**HISTORIC PRESERVATION REVIEW BOARD
STAFF REPORT AND RECOMMENDATION**

Property Address:	3501 34th Street, NW	Agenda
Landmark/District:	Cleveland Park Historic District	(X) Consent Calendar
		(X) Permit Review
Meeting Date:	April 28, 2022	(X) Alteration
H.P.A. Number:	22-088	New Construction
		Demolition
		Subdivision

Owners Janine Goodman and Gil Strobel, seek permit approval for installation of solar panels on the front and side roof elevations of their house in the Cleveland Park Historic District.

Proposed solar panel installation, 3501 34th Street NW

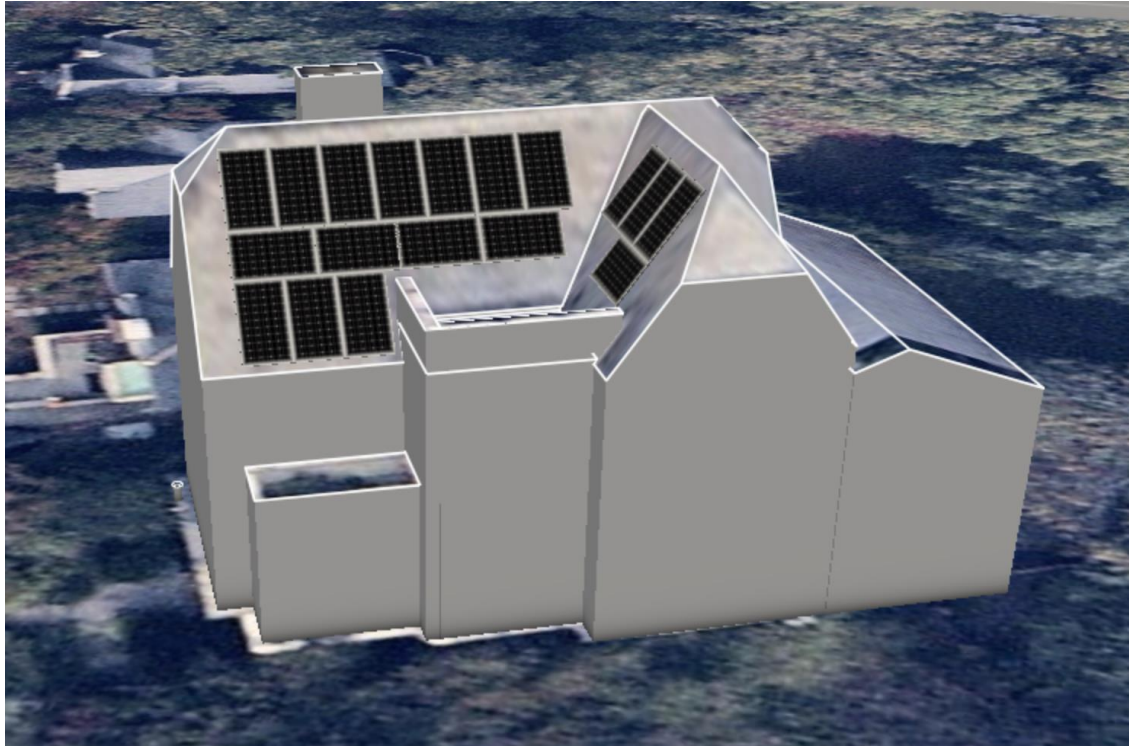
The applicants’ proposal is consistent with the guidelines. The original slate roof was failing and is in the process of being replaced with a new slate roof that is dark charcoal in color, providing a complementary field color for the panels. The array has been organized to provide offsets from roof edges and ridges (which is already required by the fire code), to avoid saw-tooth edges, and is set flush

with the roof to provide a low profile. By following the guidelines, the panels would not be discordant or incongruous with the building's roof or the streetscape of this block.

The HPO recommends that the Board find the installation of solar panels, as designed, to be consistent with its guidelines and compatible with the character of the Cleveland Park Historic District.
